Access Compliance Report Public Rights-of-Way (Curb Ramps)

Main Street: 17TH_ST Cross Street: HOLT_AVE Location: S

ADA ID: RPRK211007145234 Ramp Type: Type 4 - Parallel Initial Pass/Fail: Fail Overall Compliance: No Severity Score: 32

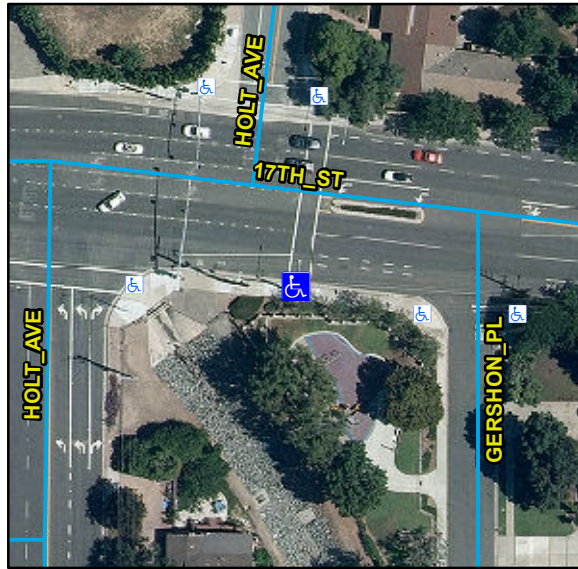
Compliance	Description	Data	Compliance	Description	Data
N/A	Ramp Length LT (in)	99	N/A	Ramp Length RT (in)	98
Yes	Ramp Width LT (in)	96	Yes	Ramp Width RT (in)	96
Yes	Ramp Run Slope LT (%)	4.4	No	Ramp Run Slope RT (%)	12.1
No	Ramp Cross Slope LT (%)	3.4	Yes	Ramp Cross Slope RT (%)	0.5
N/A	Landing Present	N/A	N/A	DWS Provided	N/A
N/A	Landing Length (in)	N/A	N/A	DWS Contrast	N/A
N/A	Landing Width (in)	N/A	N/A	DWS Length (in)	N/A
N/A	Landing Run Slope (%)	N/A	N/A	DWS Full Width	N/A
N/A	Landing Cross Slope (%)	N/A		DWS Offset Type	N/A
N/A	Landing Movement Obstructed?	N/A	N/A	DWS Offset Left (in)	N/A
	Landing Movement Type	N/A	N/A	DWS Offset Right (in)	N/A
N/A	Landing Shared	N/A			
N/A	Clear Space	N/A			
N/A	Clear Space To Crosswalk (in)	N/A			
N/A	Marked Crosswalk 1	Yes	N/A	Marked Crosswalk 2	N/A
	Crossing 1 Direction	N		Crossing 2 Direction	N/A
	Marked Crosswalk 1 Width (in)	120		Marked Crosswalk 2 Width (in)	N/A

N/A	Ramp Inside Crosswalk 1	No	N/A	Ramp Inside Crosswalk 2	N/A
	Crossing 1 Slope (%)	9.3		Crossing 2 Slope (%)	N/A
	Crossing 1 Cross Slope (%)	1.6		Crossing 2 Cross Slope (%)	N/A
N/A	Gutter Ponding	N/A	N/A	Curb Slope	12
Yes	Gutter Lip Height (in)	0		Road Run Slope (%)	N/A
N/A	Gutter Run Slope (%)	N/A		Road Cross Slope (%)	N/A
N/A	Gutter Cross Slope (%)	N/A	Yes	Perpendicular Joint Present	Yes
Yes	Overall Surface Condition	Acceptable			
	Cross Gutter Present?	No		Spandrel Present?	No
	Replace Cross Gutter?	N/A		Replace Spandrel?	N/A

Remove & Replace Entire Ramp. Restripe Crosswalk.
